## YANMAR SERVICE NEWS Spacer added to LO Temp. Control Valve Issued No.: 20-2-G-11-016-L Title Issued Date: 2020.11 (LO Thermostat), 6EY18,6EY22 Engine Use Marine Main & Aux.; Industrial Engine Model 6EY18, 6EY22 Engine Nos.

Table. Improved Item: Structure & Part No.

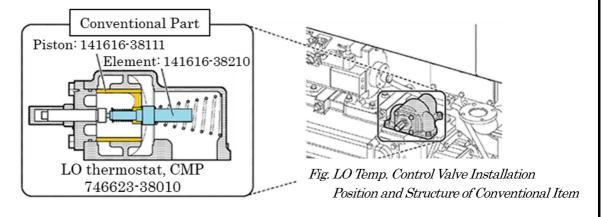
In some of 6EY18 and 6EY22 engines, malfunctioning of the LO temp, control valve (LO thermostat) was found from time to time. Upon inspection, we found that the element inside the temp. control valve by the joint section with the piston, was worn for premature damage and that this caused the valve malfunctioning in question. To control wear of the element, we have added the Spacer (A) (150633-38310) and the Spacer (B) (150633-38320) in the New Element Assembly Item, (750633-38400). For use with the future servicing, we recommend that this new item be ordered from us.

Also, when ordering the thermostat CMP (LO), Piston (LO thermostat) and Element Assembly from us for servicing 6EY18 and 6EY22 engines in future, please specify the items having the numbers (shown in green numbers) below.

To control wear, surface roughness of element joint improved. ID mark on the top.

Spacer (A): 150633-38310

Spacer (B): 150633-38320
